Access Compliance Report Public Rights-of-Way (Curb Ramps)

Main Street: TUBEROSE_ST Cross Street: AGAPANTHUS_ST Location: NE

ADA ID: RPRK211111123146 Ramp Type: Type 4 - Parallel Initial Pass/Fail: Pass Overall Compliance: No Severity Score: 26

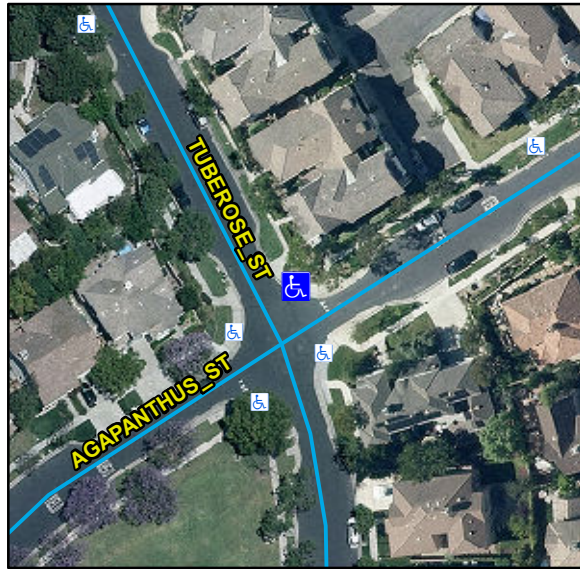
Compliance	Description	Data	Compliance	Description	Data
N/A	Ramp Length LT (in)	131	N/A	Ramp Length RT (in)	135
Yes	Ramp Width LT (in)	52	Yes	Ramp Width RT (in)	52
Yes	Ramp Run Slope LT (%)	1.5	Yes	Ramp Run Slope RT (%)	5.6
No	Ramp Cross Slope LT (%)	2.3	No	Ramp Cross Slope RT (%)	2.4
N/A	Landing Present	No	No	DWS Provided	No
N/A	Landing Length (in)	N/A	N/A	DWS Contrast	N/A
No	Landing Width (in)	N/A	N/A	DWS Length (in)	N/A
No	Landing Run Slope (%)	N/A	N/A	DWS Full Width	N/A
No	Landing Cross Slope (%)	N/A		DWS Offset Type	N/A
N/A	Landing Movement Obstructed?	No	N/A	DWS Offset Left (in)	N/A
	Landing Movement Type	Curb	N/A	DWS Offset Right (in)	N/A
N/A	Landing Shared	N/A			
N/A	Clear Space	Yes			
N/A	Clear Space To Crosswalk (in)	48			
N/A	Marked Crosswalk 1	No	N/A	Marked Crosswalk 2	No
	Crossing 1 Direction	W		Crossing 2 Direction	S
N/A	Marked Crosswalk 1 Width (in)	N/A		Marked Crosswalk 2 Width (in)	N/A
N/A	Ramp Inside Crosswalk 1	N/A	N/A	Ramp Inside Crosswalk 2	N/A

Crossing 1 Slope (%)	2.7		Crossing 2 Slope (%)	1.8
	Crossing 1 Cross Slope (%)	3.1		Crossing 2 Cross Slope (%)	1
Yes	Gutter Ponding	No	N/A	Curb Slope	4.4
Yes	Gutter Lip Height (in)	0		Road Run Slope (%)	2.4
No	Gutter Run Slope (%)	9.8		Road Cross Slope (%)	4.8
Yes	Gutter Cross Slope (%)	1.5	No	Perpendicular Joint Present	No
Yes	Overall Surface Condition	Acceptable			
	Cross Gutter Present?	No		Spandrel Present?	No
	Replace Cross Gutter?	N/A		Replace Spandrel?	N/A

Remove & Replace Curb Ramp With Two New Directional Ramps or Equivalent. Remove & Replace Gutter.
